Planning Commission Staff Report

SUBJECT: PUD-109

PURPOSE: Work Session to review and receive comments on applications for

LOCATION: 273 Spring Street

Figure 5: Proposed Color and Material Scheme

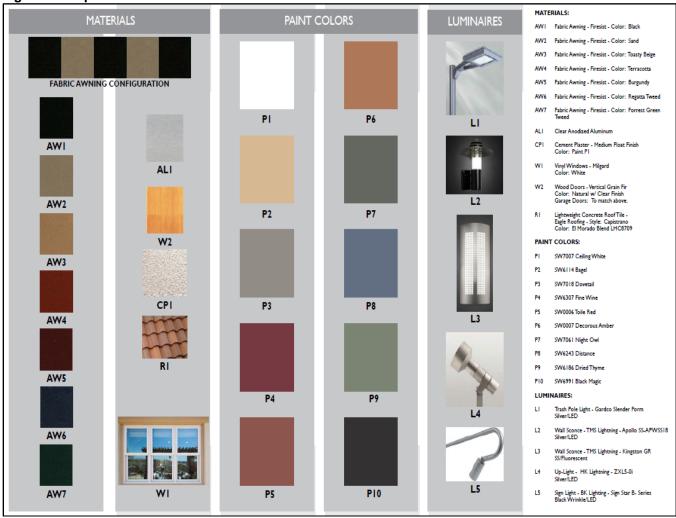
The proposed townhouses are designed in a contemporary architectural style, which features both flat and curved roof parapet lines, smooth cement plaster walls painted white, a significant amount of glazing, and metal deck/balcony railings (Figure 4). However, the modern design incorporates traditional elements, such as tile roofing and smooth cement plaster walls.

Staff initially had concerns that the building massing of the proposed townhouses was incompatible with the neighborhood, which primarily comprises one-story commercial and single-family detached homes. The applicant revised the plans multiple times to improve the finish material quality (smooth cement plaster, awnings, etc.) of the overall proposal and to also add architectural interest (storefront windows at the street level, decorative and varying roofline parapets, etc.), wall plane articulation (variable second floor wall planes, dormer elements, etc.) and movement to the front and rear elevations of the proposed commercial/office building, as well as the proposed townhouses, increasing the proposal's consistency with the Downtown Design Guidelines. Additionally, the applicant reduced the height of the proposed townhouses to 30 feet, which is considered acceptable in most residential zones within the City. Staff believes these revisions make the plan more consistent with the Downtown Specific Plan Land Use Policy No. 1 that states: "In order to preserve the historic character of the Downtown, new or remodeled buildings within the Downtown Commercial area should be limited to two stories, except three-story buildings may be allowed on a case-by-case basis provided: (1) the buildings are pedestrian in scale, and include features such as first-story storefront windows, recessed entries, building details, and awnings; (2) buildings are designed to minimize their three-story appearances through use of techniques such as dormer windows, stepping back upper floors, and using design features between building levels to assist in maintaining an overall horizontal design character to the building; and (3) buildings must conform with the City Municipal Code height limits." Downtown Specific Plan Land Use Policy No. 15 refers to Municipal Code Section 18.84, limiting building heights in residential areas and future PUDs in the Downtown to two stories and no more than 30 feet. Staff believes the proposal is consistent with a reasonable interpretation of the Downtown Specific Plan Land Use policies.

- E. Does the Planning Commission believe the proposal is consistent with the Downtown Specific Plan Land Use policies related to height, design, massing, etc.?
- F. Are the proposed building designs, area, massing, number of stories, heights, and colors and materials acceptable and compatible with the surrounding area?
